Access Compliance Report

Public Rights-of-Way

(Curb Ramps)

| Intersection ID: 19805 | Main Street: MORRISON_BV | Cross Street: SOUTH_PARK_DR | Location: NW |

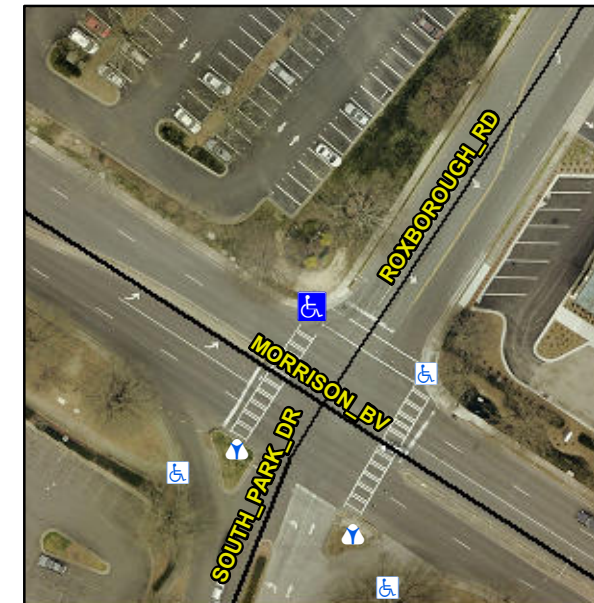
Remove & Replace Curb Slope and Extend Ramp. Remove & Replace Gutter.

LT RP < 5%

Not Found, R304.5.3

| Compliance | Description | Data | Compliance | Description | Data |
|------------|----------------------|-------|------------|-----------------------------|-------|
| Yes | Gutter Lip Ht (in) | 0.0 | No | Gutter X Slope (%) | 2.7 |
| | | | Replace | Curb Slope (%) | 8.6 |
